From: [Paulina Lopez](#)
To: [Johnson, Beau \(ECY\)](#); [Waldref, Meredith \(ECY\)](#)
Subject: Industrial Container Services Public Comment DRCC
Date: Friday, January 31, 2025 11:40:29 AM
Attachments: [Memo_ Industrial Container Services Remedial Investigation and Feasibility Study.docx.pdf](#)

Re: Industrial Container Services (ICS) Remedial Investigation (RI) and Feasibility Study (FS)

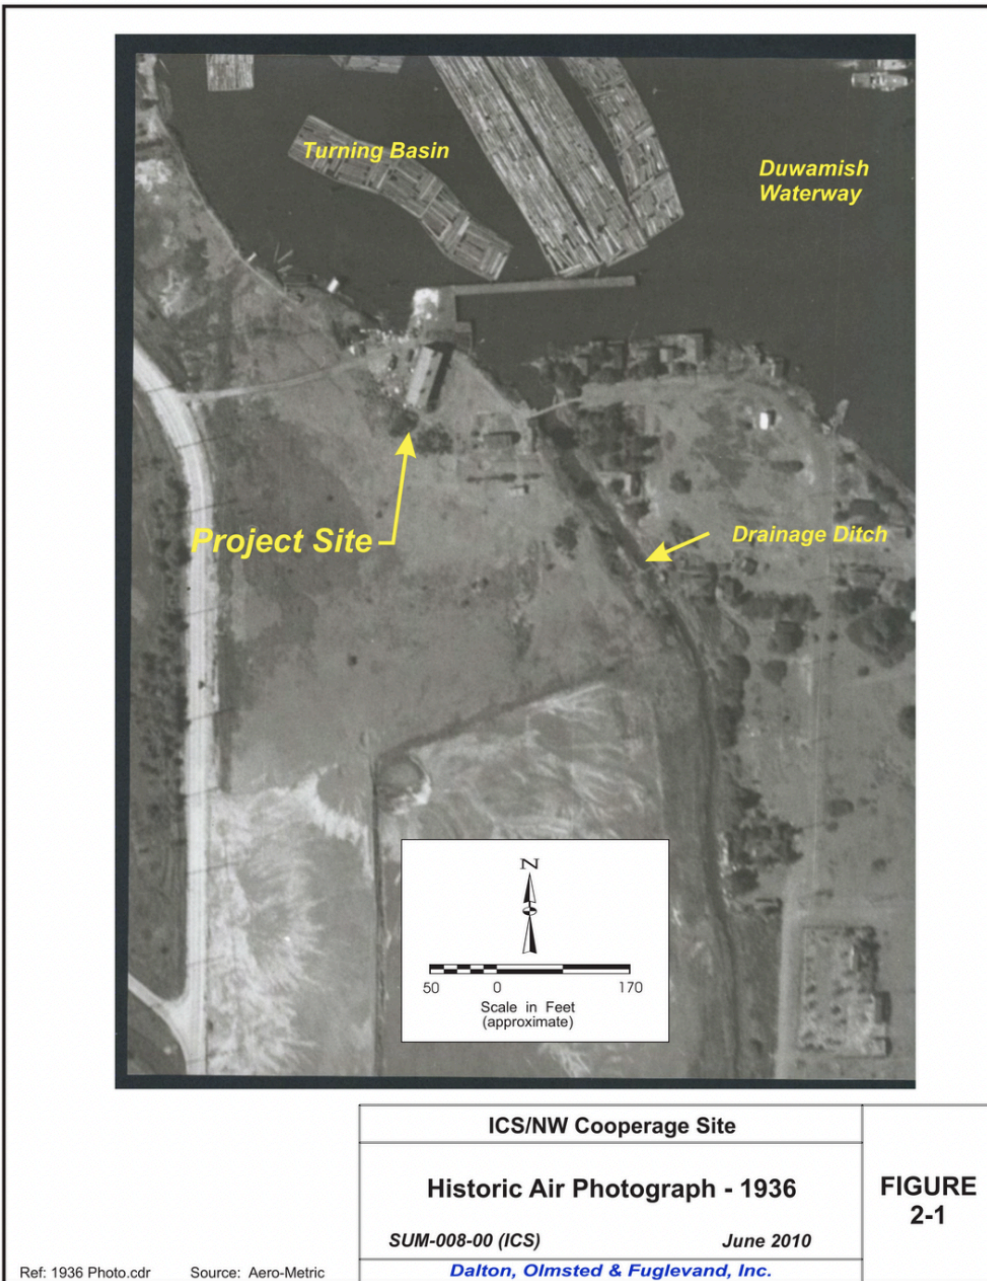
9. Address potential contributions of the former ditch

A surficial drainage ditch occupied the property until it was filled in the late 1960s (shown in Figure 2-1). A portion of this ditch was used as a wastewater settling lagoon. The filled-in ditch now flows in a buried storm water drainage pipe to the 2nd Avenue Outfall.

As noted in the RI/FS the samples from wells near the former drainage ditch had estuarine water contributions that ranged between 49% and 87%. This suggests a high degree of exchange between the river and the former drainage ditch soils and groundwater.

The former ditch has high levels of arsenic, total chromium, lead, zinc, sum 4,4'-DDE, -DDD, -DDT, DRO/RROs, and total PCBs near the bottom of the filled-in drainage ditch. While the RI/FS states that "Available groundwater analytical data indicate that PCBs and DRO/RRO are not migrating in groundwater above SLs from the filled-in drainage ditch", the presence of high levels of contaminants and a clear pathway to the

Duwamish River indicate additional and focused sampling is needed.
